MEETS LOAD CASE 1 AND SOME OTHER SAFETY REQUIREMENTS CALCULATED BY HAO, IS AN INCOMPLETE REPORT AND FAILS MOST LOAD CASES

HiWind 2024 Structural Analysis

4/30/2024

Load Case 1 Upper Gondola

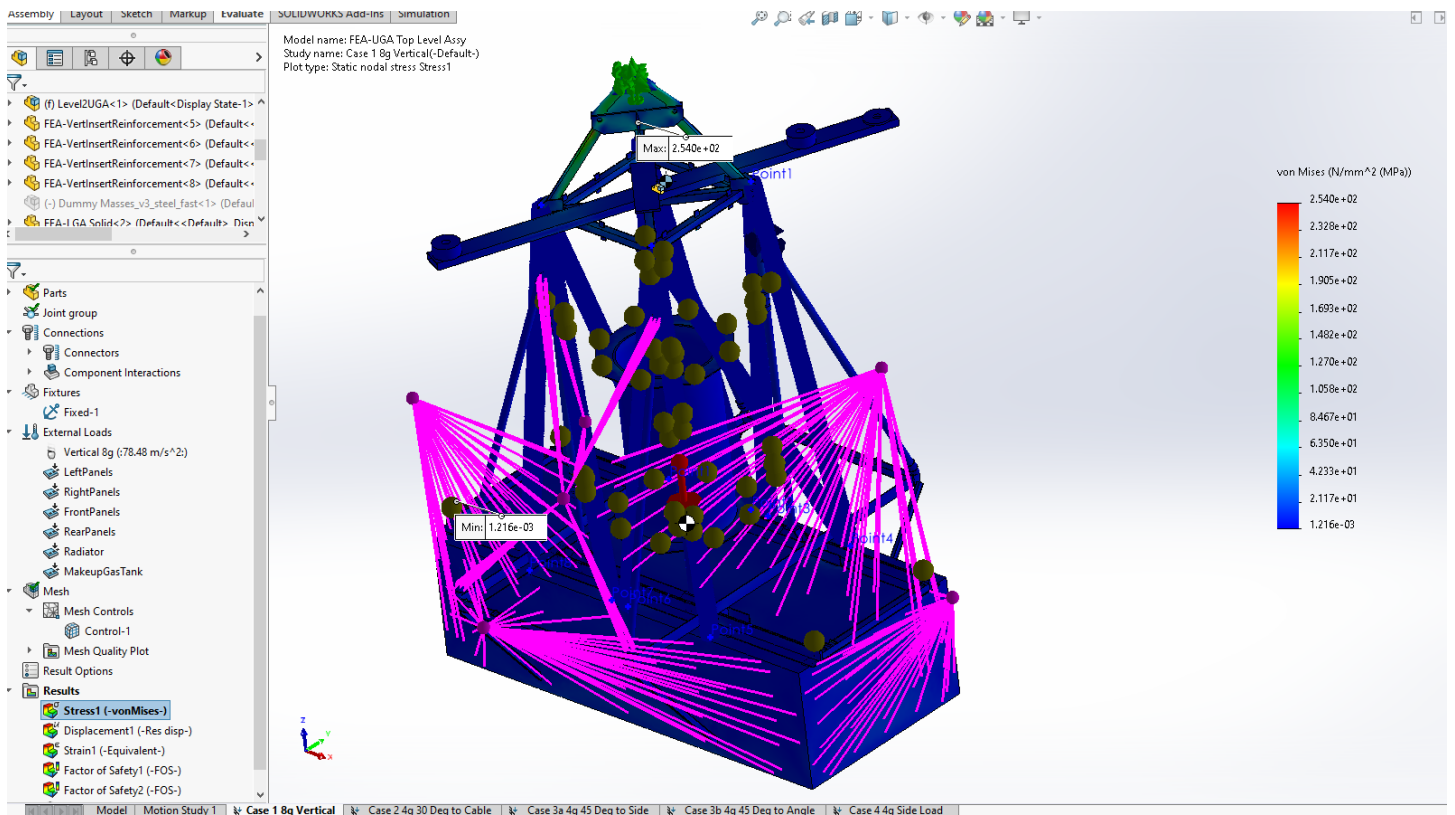
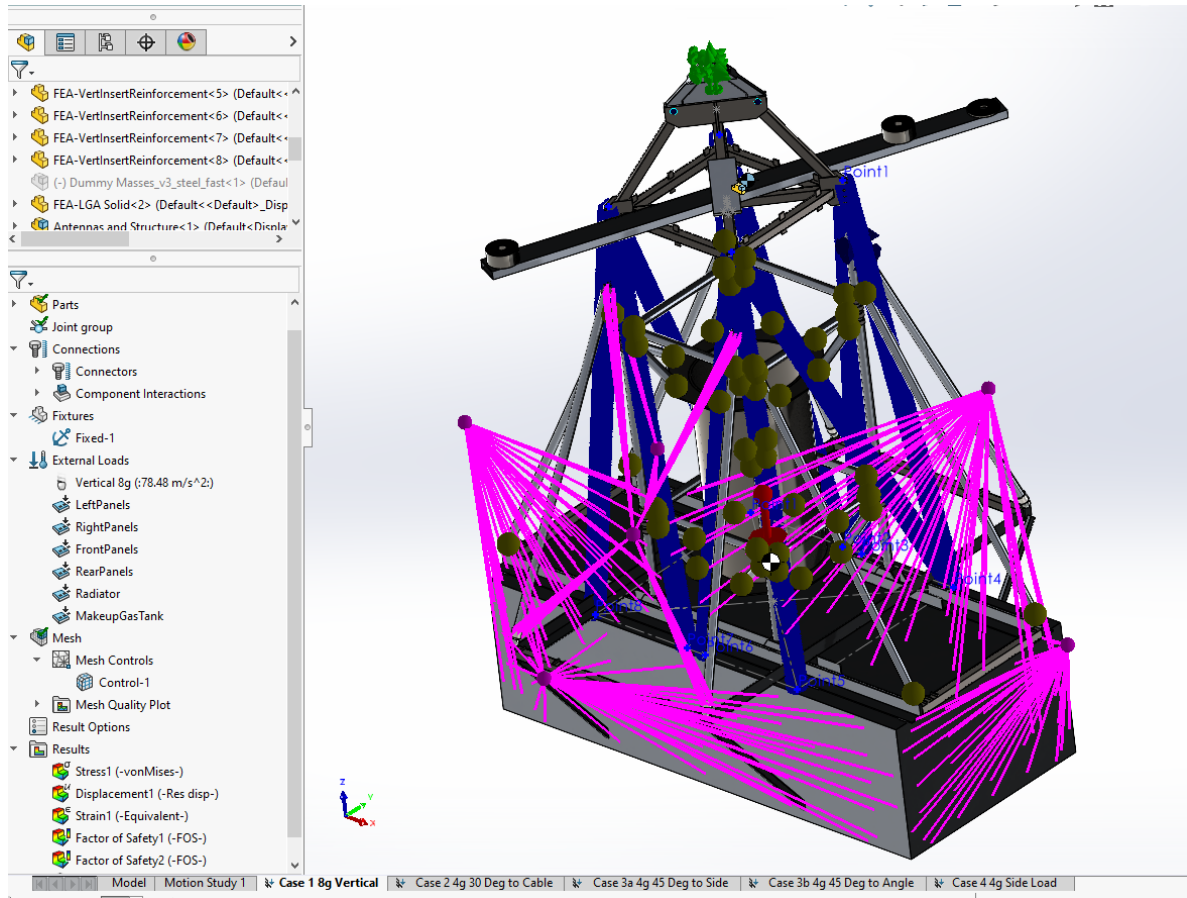
The KeeClamp joining member has a low FOS, the min FOS from the assembly and the max stress of a node in any part will be used in the Safety Factor calculation. Steel is used in the Margin of Safety calculation as the material, as the fastener taking the load is steel.

| Case 1 8g Vertical | | | | | | | | |
|----------------------|-----|------|-----|-----------|---|------------------|--|------------------|
| | MSu | 1.11 | FSu | 1.25 | P | 2.54E+02 MPa | | 1.48 FOS |
| | MSy | 0.22 | FSy | 1.40 | P | 2.54E+02 MPa | | 1.48 FOS |

Load Case 2 Upper Gondola

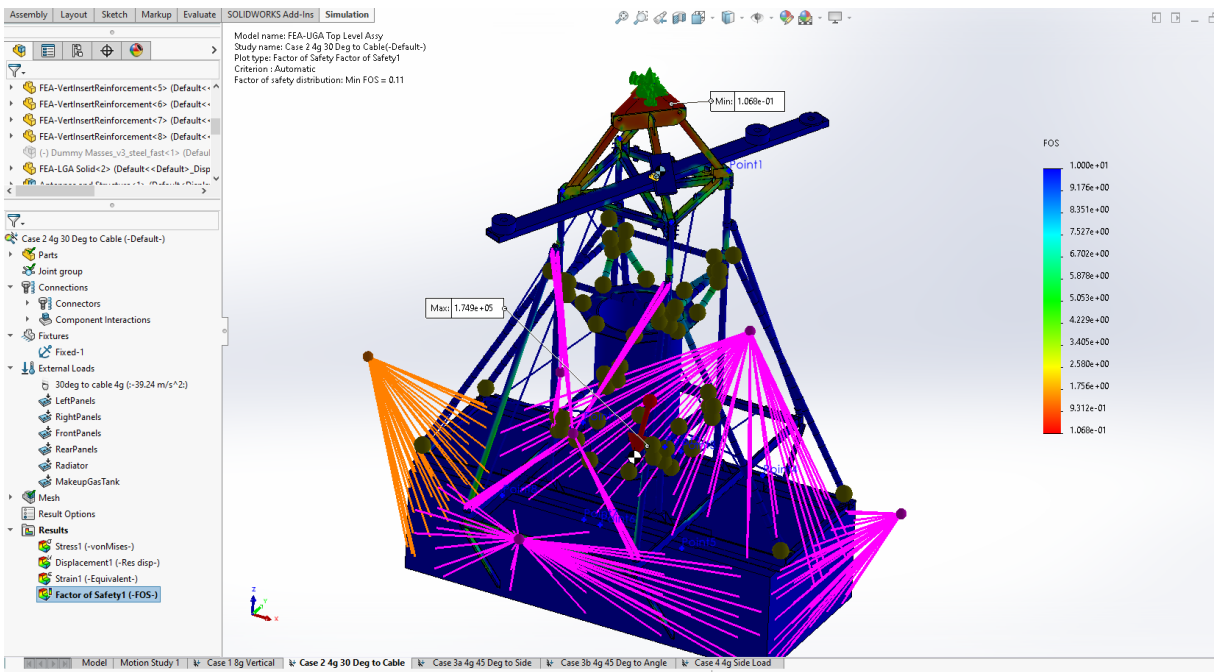
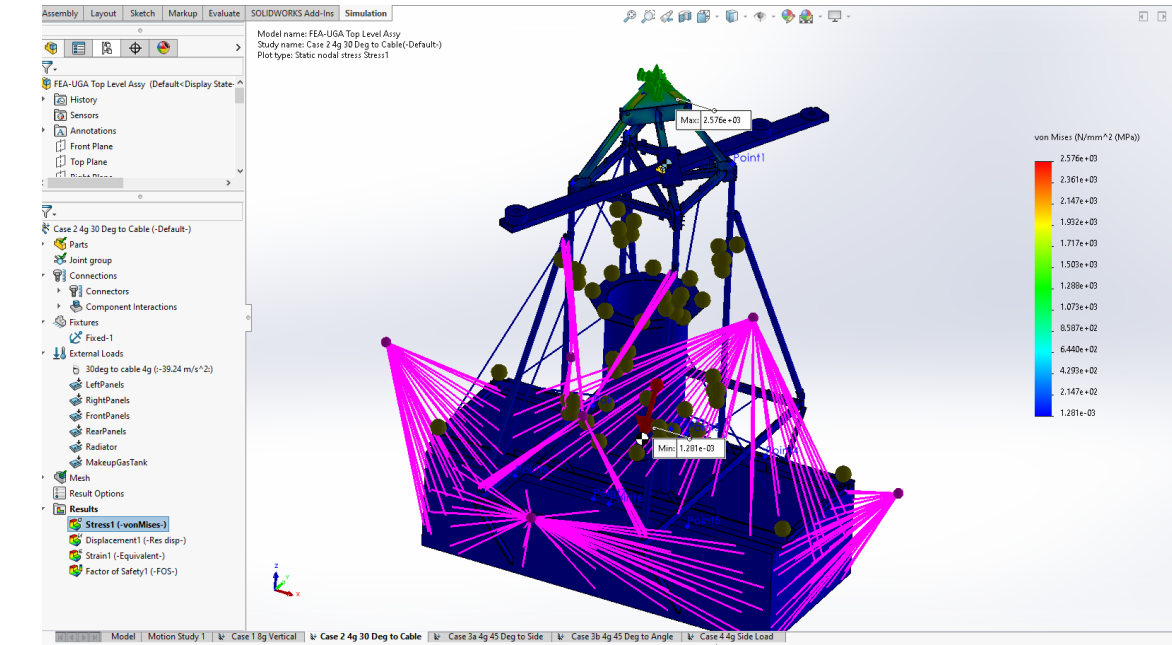
The upper gondola does not pass this case. The lowest factor of safety is in the triplate.

| Case 2 4g 30 Degree to Cable | | | | From NASA | Maximum From FEA | Minimum From FEA | |
|------------------------------|-----|-------|-----|-----------|------------------|------------------|-----|
| | MSu | -0.90 | FSu | 1.25 | P 2.58E+03 MPa | 0.11 | FOS |
| | MSy | -0.92 | FSy | 1.40 | P 2.58E+03 MPa | 0.11 | FOS |

Load Case 3a Upper Gondola

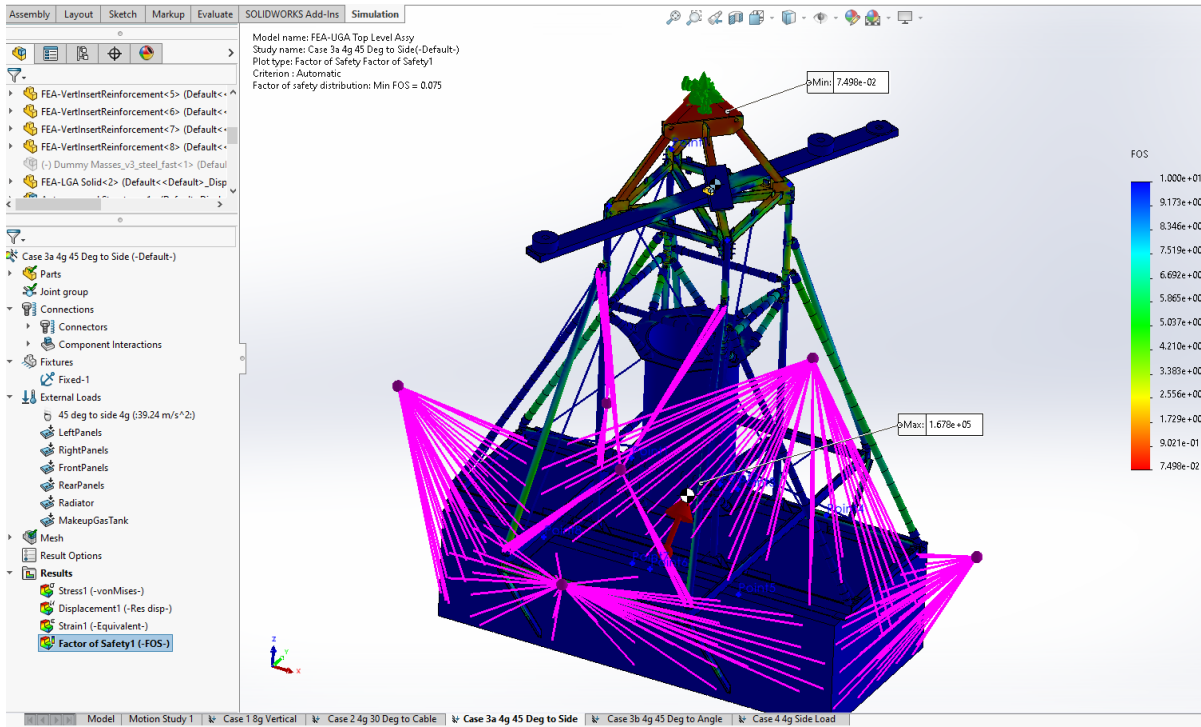
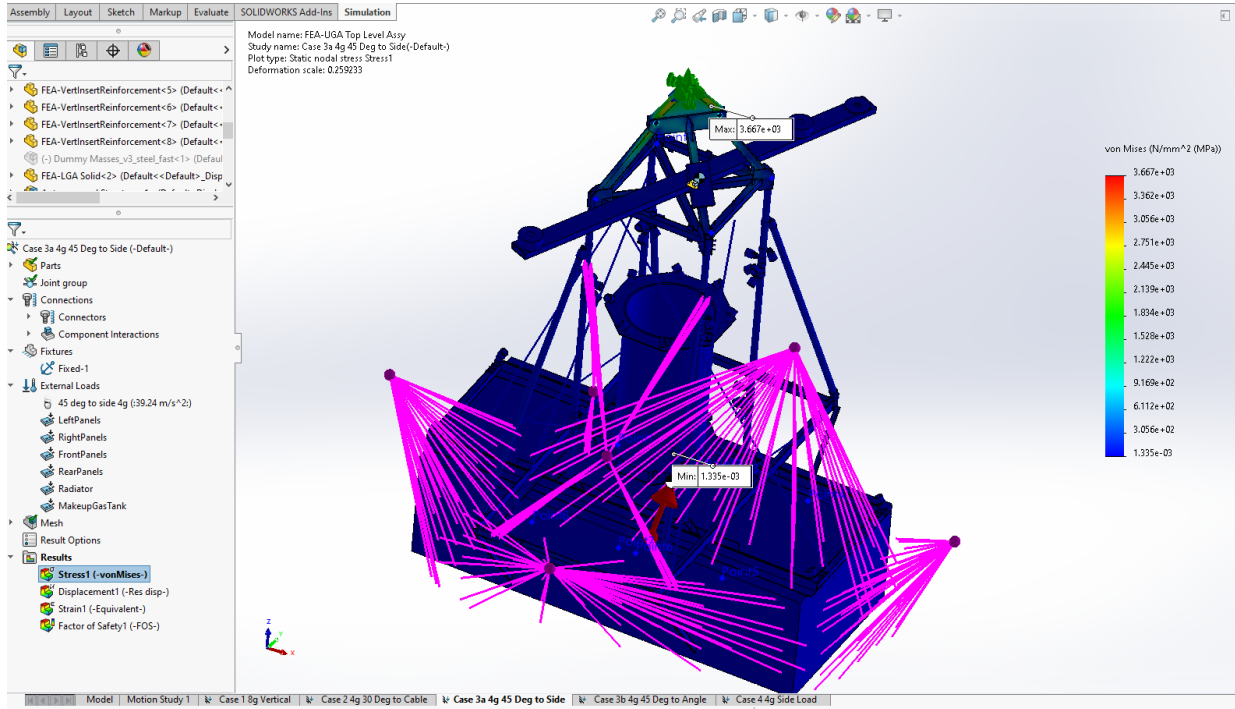
| | | From NASA | Maximum From FEA | Minimum From FEA | | |
|----------------------|-------|-----------|------------------|------------------|-----|--|
| MSu | -0.93 | FSu 1.25 | P 3.67E+03 MPa | 0.08 | FOS | |
| MSy | -0.95 | FSy 1.40 | P 3.67E+03 MPa | 0.08 | FOS | |

Load Case 3b Upper Gondola

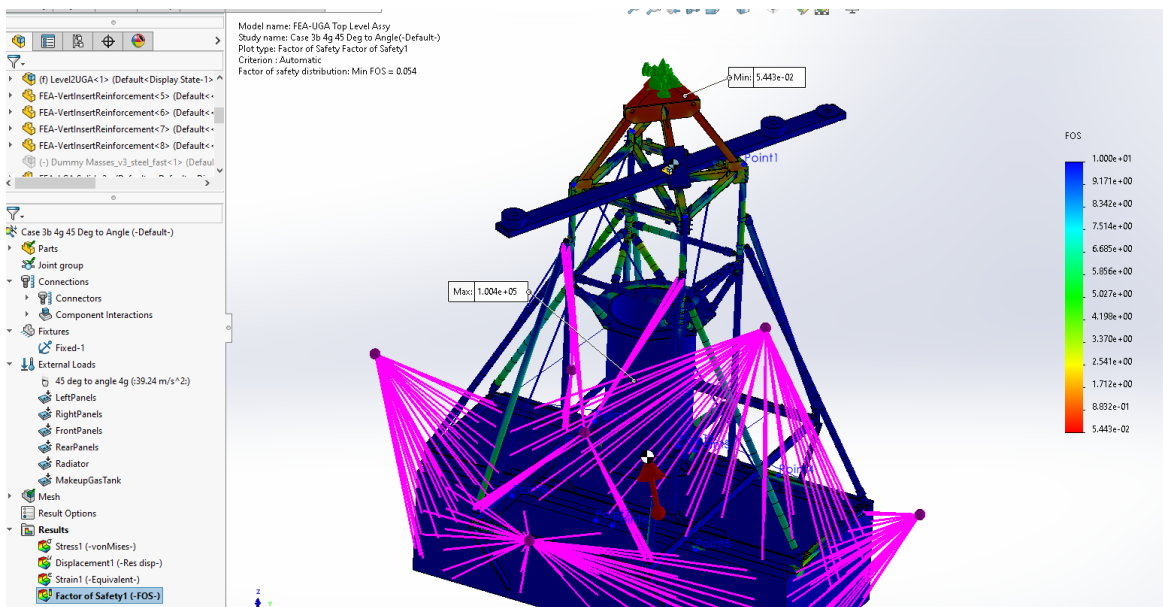
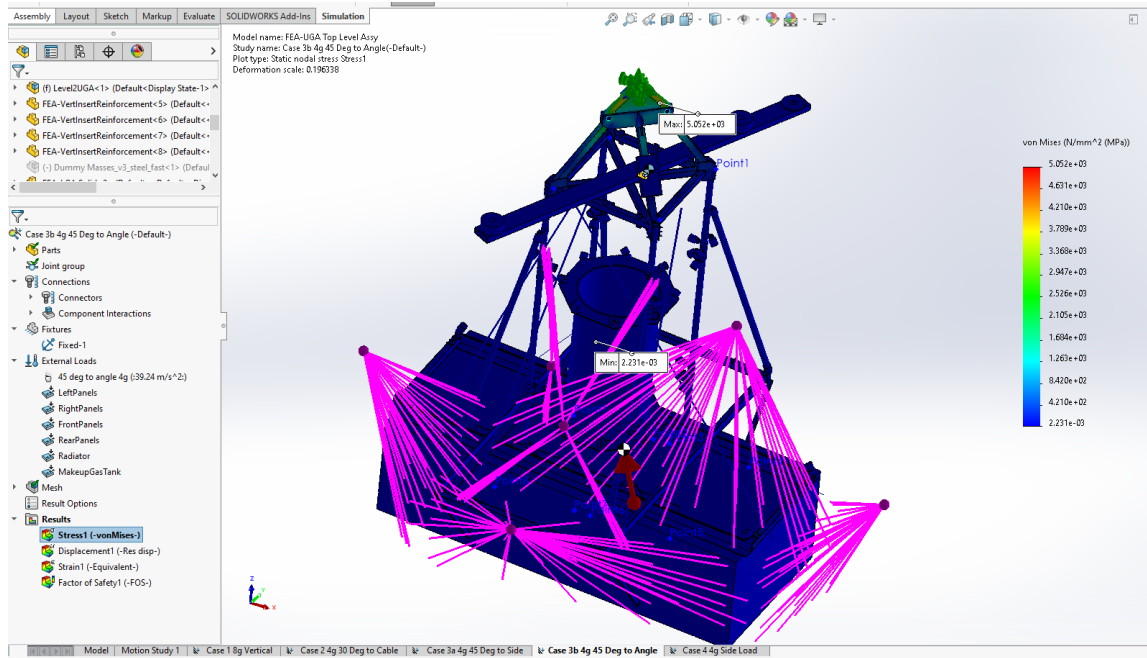
| Case 3b 45 Degree to Vertical | | | | | | | | |
|-------------------------------|-----|-------|-----|-----------|---|------------------|--|------------------|
| | MSu | -0.95 | FSu | 1.25 | P | 5.05E+03 MPa | | 0.05 FOS |
| | MSy | -0.96 | FSy | 1.40 | P | 5.05E+03 MPa | | 0.05 FOS |

Load Case 4 Upper Gondola

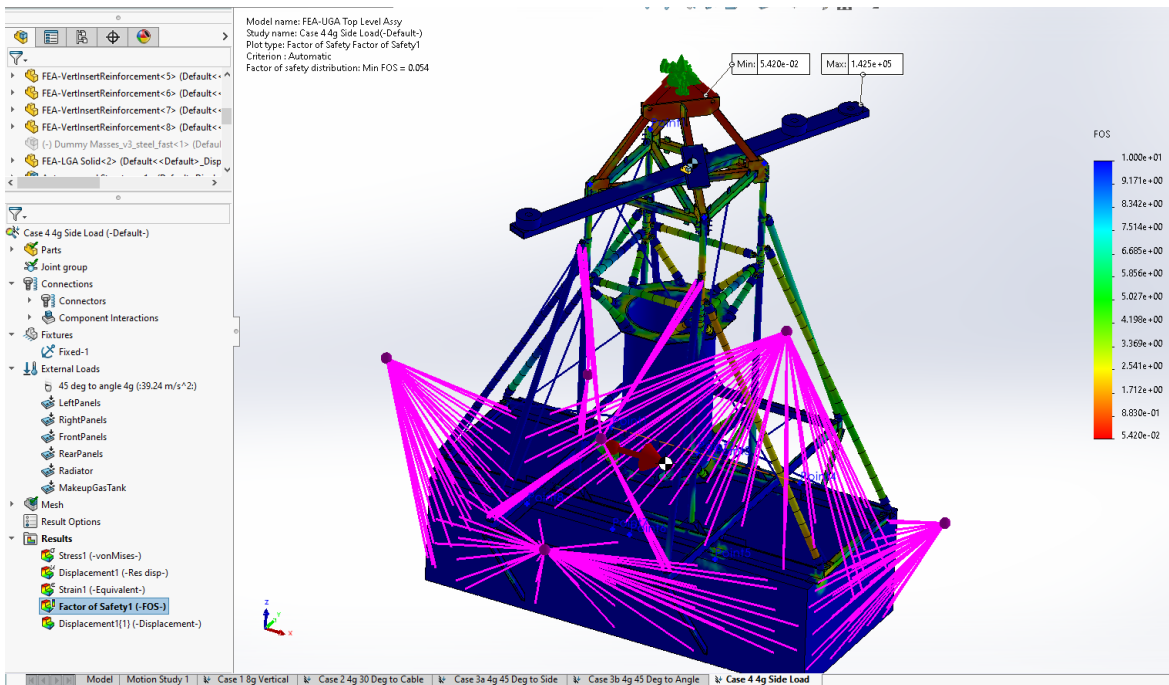
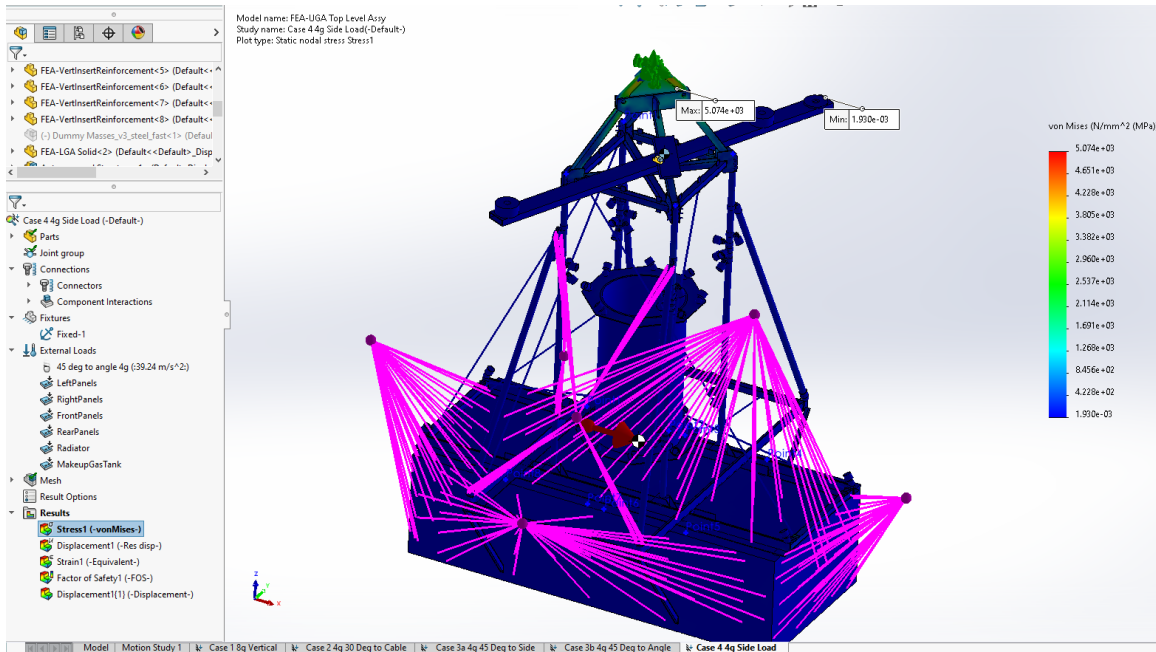
| Case 4 4g Side Load | | | From NASA | | Maximum From FEA | | Minimum From FEA | |
|----------------------|-----|-------|-----------|------|------------------|--------------|------------------|-----|
| | MSu | -0.95 | FSu | 1.25 | P | 5.10E+03 MPa | 0.05 | FOS |
| | MSy | -0.96 | FSy | 1.40 | P | 5.10E+03 MPa | 0.05 | FOS |

Trapeze 8g Case

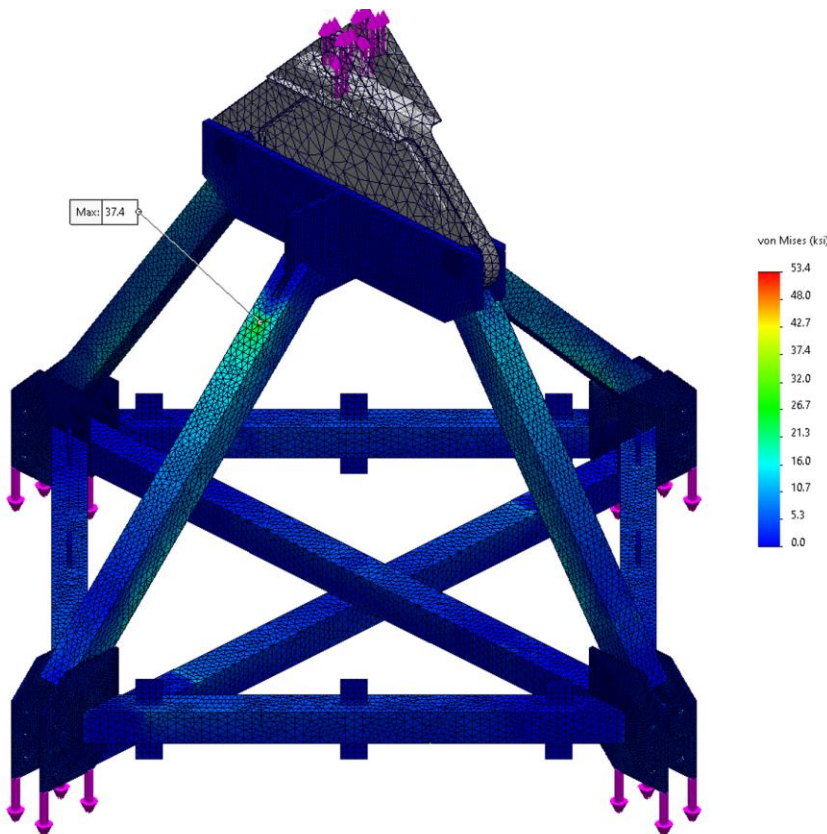
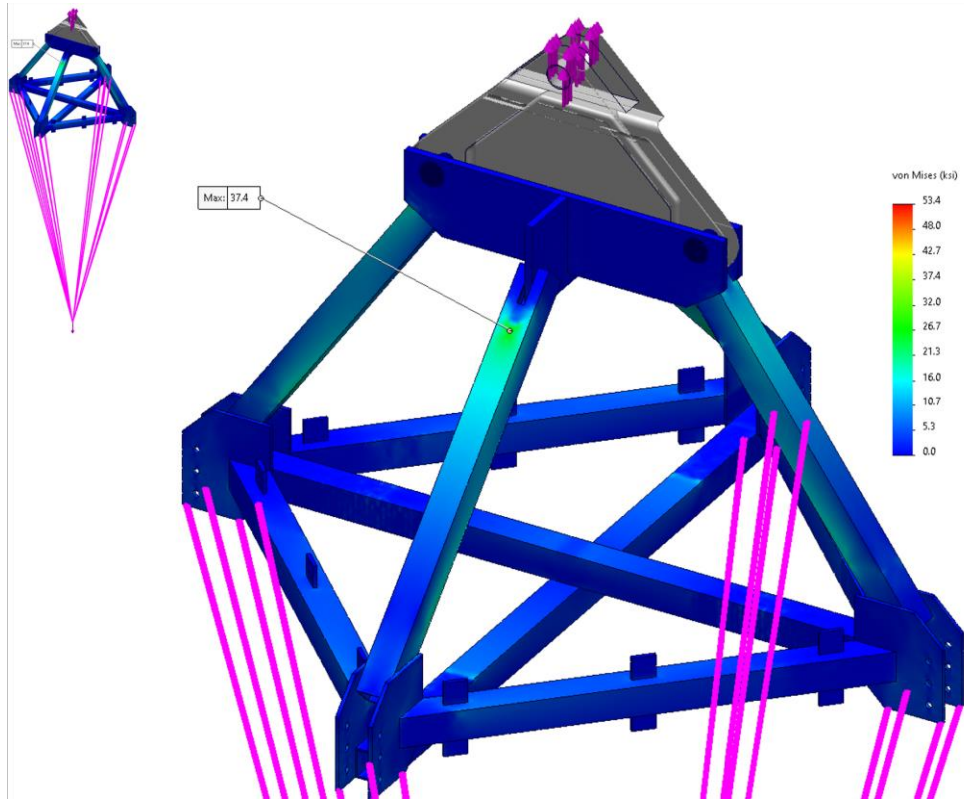
The structural review team asked that I do an independent analysis of the trapeze for all load cases. I've finished with that and it shows good margins. They're requesting that you perform a similar analysis to verify my results. I believe they'll ask for this to be presented at the final PIR as a way to allow us to certify the gondola for flight in FY25.

- Force = 33,600lbf
 - 4,200lbs below trapeze
- Inertial Relief
 - Equal force distribution at bottom of trapeze
- Tri-Plate Rigid

- $F_{ty} = 750 \text{ Mpa} = 108.8 \text{ ksi}$
- $F_{tu} = 1,000 \text{ Mpa} = 145.0 \text{ ksi}$
 - *Carlile reports: $F_{ty} = 435 \text{ Mpa} / F_{tu} = 670 \text{ Mpa}$*

- $\sigma_{\text{max}} = 37.4 \text{ ksi}$
- $M_{sy} = 0.35$
- $M_{su} = 0.86$

This analysis doesn't consider any of the antennae specific loads and combines those antennae loads with the total mass. The tri-plate is aluminum, so it is the softest part in the entire assembly and its bending will affect the load paths. This model is a simple check to be compared with Justin's results with similar assumptions.
